Access Compliance Report Public Rights-of-Way (Curb Ramps)

Main Street: NEWLAND_ST Cross Street: WASHINGTON_AVE Location: SW

ADA ID: RPRK211001113927 Ramp Type: Type 1 - Perpendicular Diagonal Initial Pass/Fail: Fail Overall Compliance: No Severity Score: 2

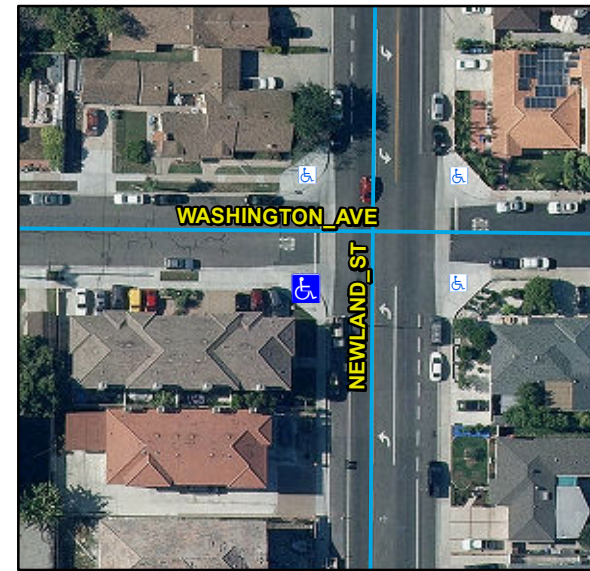
Compliance	Description	Data	Compliance	Description	Data
N/A	Ramp Length (in)	110	N/A	Flare Type LT	
Yes	Ramp Width (in)	48			N/A
Yes	Ramp Run Slope (%)	2.9	N/A	Flare Slope LT (%)	N/A
No	Ramp Cross Slope (%)	3.2	N/A	Flare Traversable LT	N/A
N/A	Landing Present	N/A	N/A	Flare Type RT	
N/A	Landing Length (in)	N/A			N/A
N/A	Landing Width (in)	N/A	N/A	Flare Slope RT (%)	N/A
N/A	Landing Run Slope (%)	N/A	N/A	Flare Traversable RT	N/A
N/A	Landing Cross Slope (%)	N/A	N/A	DWS Provided	N/A
N/A	Landing Movement Obstructed?	N/A	N/A	DWS Contrast	N/A
	Landing Movement Type	N/A	N/A	DWS Length (in)	N/A
N/A	Landing Shared	N/A	N/A	DWS Full Width	N/A
N/A	Clear Space	Yes	N/A	DWS Offset Left (in)	N/A
N/A	Clear Space To Crosswalk (in)	N/A	N/A	DWS Offset Right (in)	N/A
N/A	Marked Crosswalk 1	No	N/A	Marked Crosswalk 2	No
	Crossing 1 Direction	E		Crossing 2 Direction	N
	Marked Crosswalk 1 Width (in)	N/A		Marked Crosswalk 2 Width (in)	N/A

N/A	Ramp Inside Crosswalk 1	N/A	Yes	Ramp Inside Crosswalk 2	N/A
	Crossing 1 Slope (%)	8.9		Crossing 2 Slope (%)	1.6
	Crossing 1 Cross Slope (%)	1.6		Crossing 2 Cross Slope (%)	3
N/A	Gutter Ponding	N/A	No	Curb Slope	7.8
Yes	Gutter Lip Height (in)	0		Road Run Slope (%)	1.4
N/A	Gutter Run Slope (%)	N/A		Road Cross Slope (%)	1.1
N/A	Gutter Cross Slope (%)	N/A			
Yes	Overall Surface Condition: Acceptable		Yes	Perp Joint Present	Yes
	Cross Gutter Present?	Yes		Spandrel Present?	Yes
	Replace Cross Gutter?	No		Replace Spandrel?	No

Possible Solutions:
Remove & Replace Curb Ramp With Two New Directional Ramps or Equivalent.

OC Std/PROW:
R304.2.2, R304.5.3, STD 1115
